TECHNICAL NOTE

Job Name: Bicester Gateway Phase 1b Residential
Job No: 46463
Note No: 006
Date: 30 April 2020
Prepared By: Francois Chate
Subject: Response to OCC comments 23rd March 2020

This Technical Note (TN) provides our response to comments raised by Oxfordshire County Council (OCC) on the transport and highway material submitted in support of the Bicester Gateway Phase 1b planning application.

Appendix A – Figure 12 from DAS – Regulation Plan

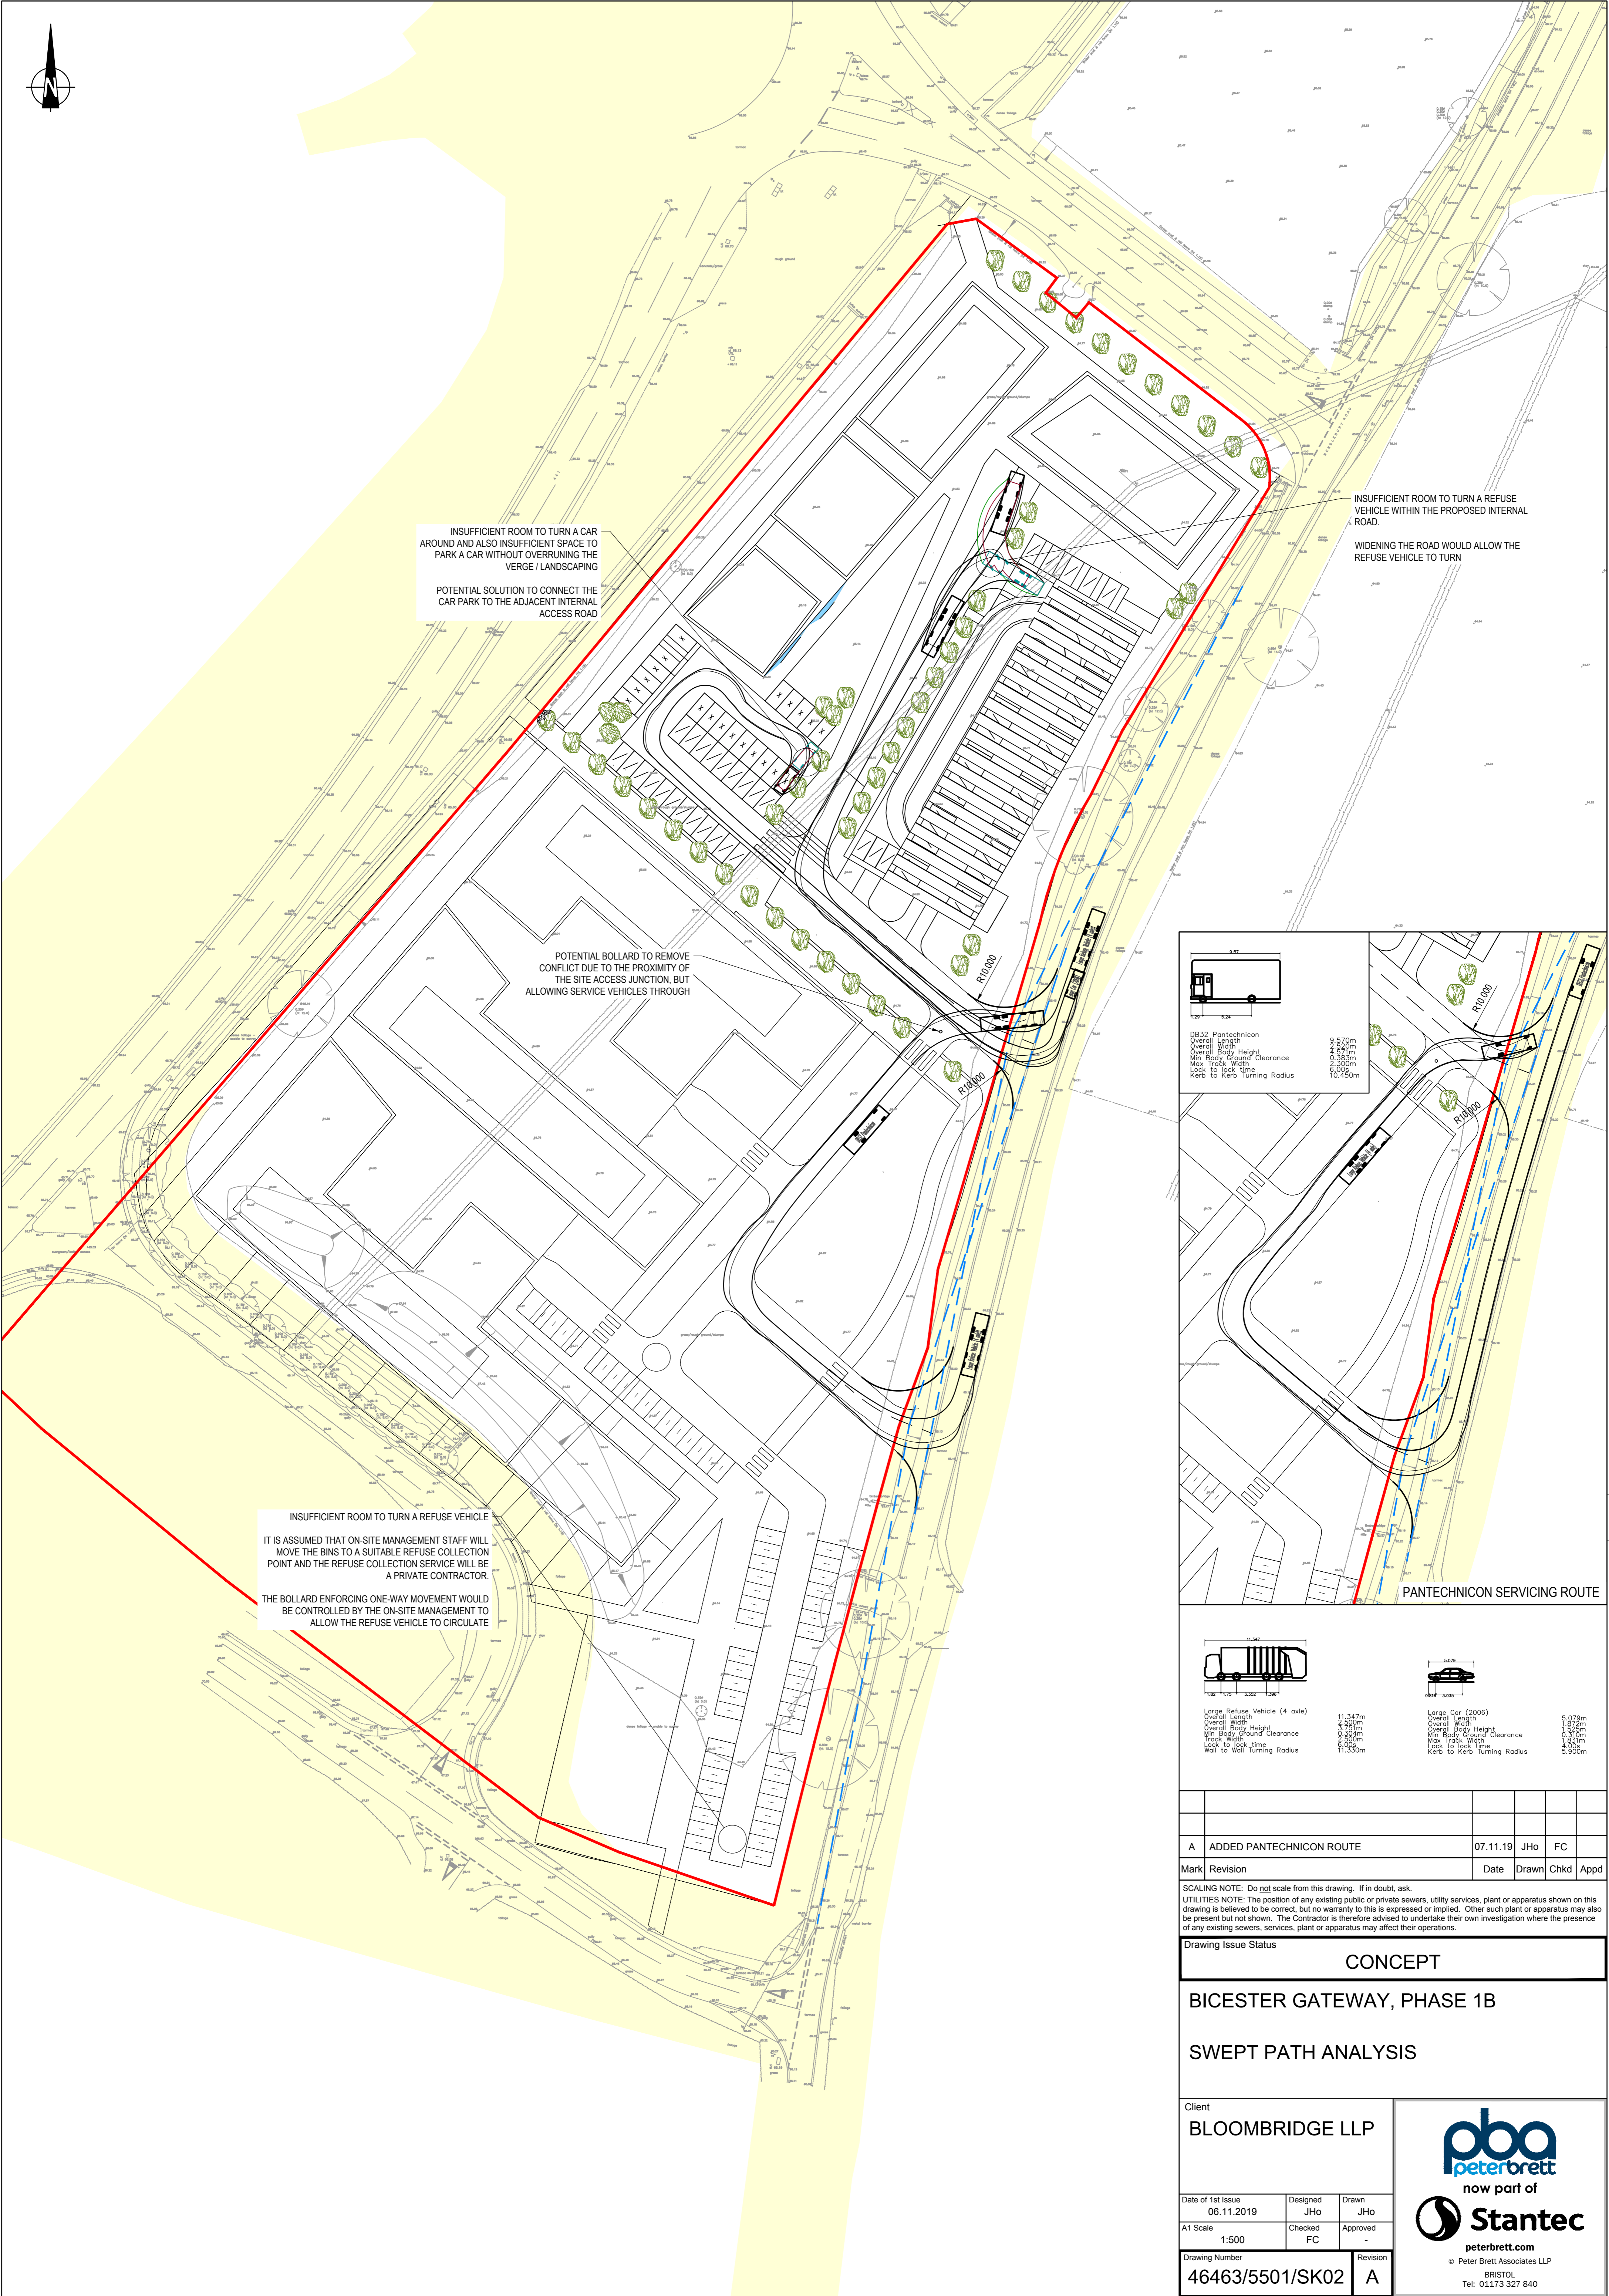
- 2.25. The Regulating Plan for Phase 1b (Figure 12 of the Design & Access Statement) shows (in yellow arrows) two possible points of future connections with Phase 2, plus Vendee Drive, for the promoters of Phase 2 to respond to in their own Master Plan and Regulating Plan. This is designed to provide for the optimisation of accessibility, notably to the Park & Ride, but it is for Phase 2 to provide these connections in line with whatever development programme emerges for Phase 2 – because there is nowhere to go to until Phase 2 is developed. Figure 12 is extracted and shown in **Appendix A** to this note.

Appendix B – Tracking Drawing

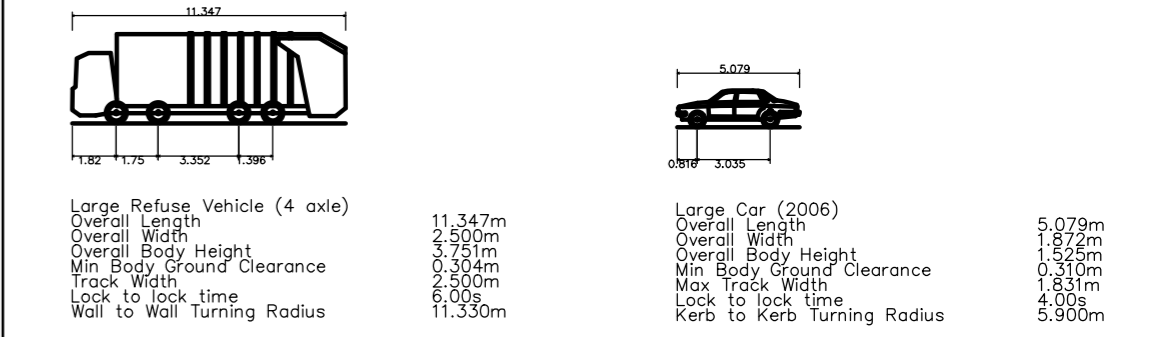
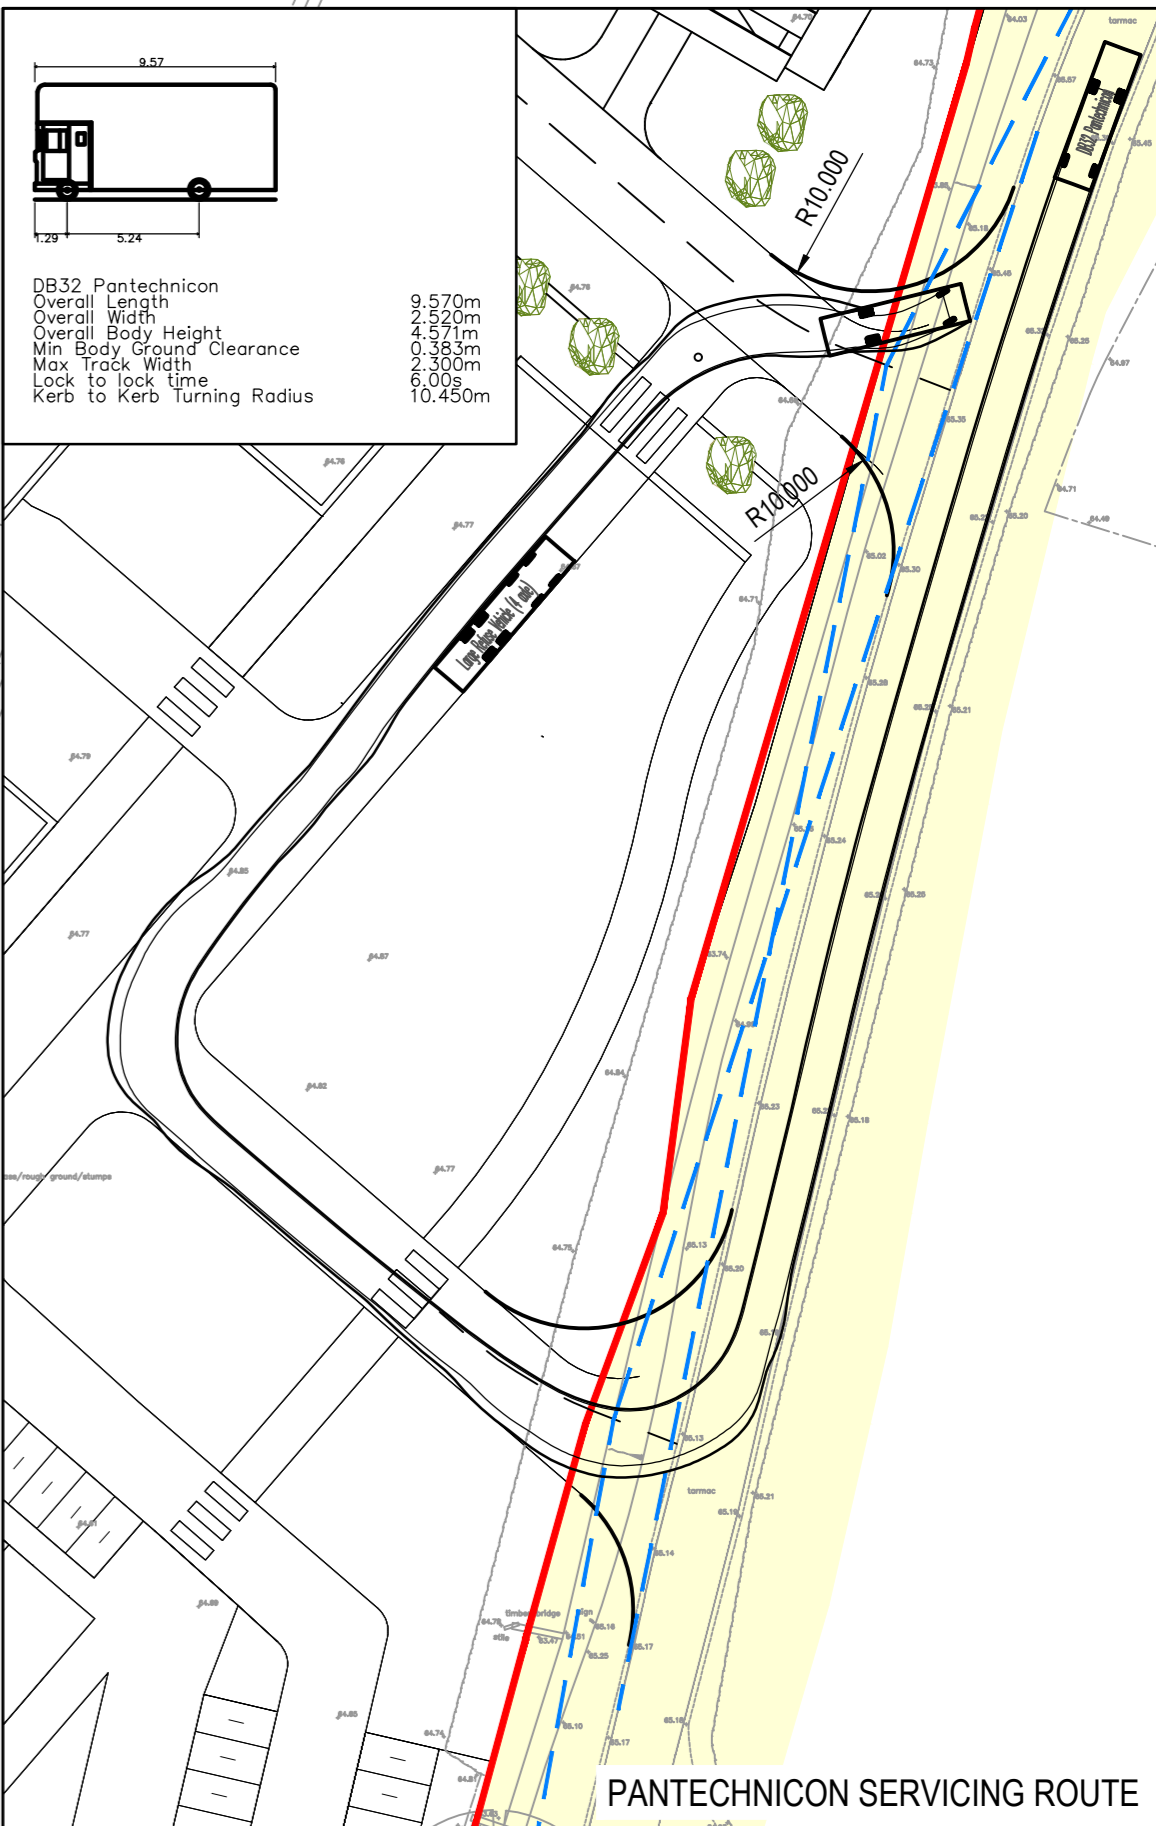
INSUFFICIENT ROOM TO TURN A CAR AROUND AND ALSO INSUFFICIENT SPACE TO PARK A CAR WITHOUT OVERRUNNING THE VERGE / LANDSCAPING

POTENTIAL BOLLARD TO REMOVE CONFLICT DUE TO THE PROXIMITY OF THE SITE ACCESS JUNCTION, BUT ALLOWING SERVICE VEHICLES THROUGH

INSUFFICIENT ROOM TO TURN A REFUSE VEHICLE WITHIN THE PROPOSED INTERNAL ROAD.

INSUFFICIENT ROOM TO TURN A REFUSE VEHICLE

POTENTIAL SOLUTION TO CONNECT THE CAR PARK TO THE ADJACENT INTERNAL ACCESS ROAD

WIDENING THE ROAD WOULD ALLOW THE REFUSE VEHICLE TO TURN

IT IS ASSUMED THAT ON-SITE MANAGEMENT STAFF WILL MOVE THE BINS TO A SUITABLE REFUSE COLLECTION POINT AND THE REFUSE COLLECTION SERVICE WILL BE A PRIVATE CONTRACTOR.

THE BOLLARD ENFORCING ONE-WAY MOVEMENT WOULD BE CONTROLLED BY THE ON-SITE MANAGEMENT TO ALLOW THE REFUSE VEHICLE TO CIRCULATE
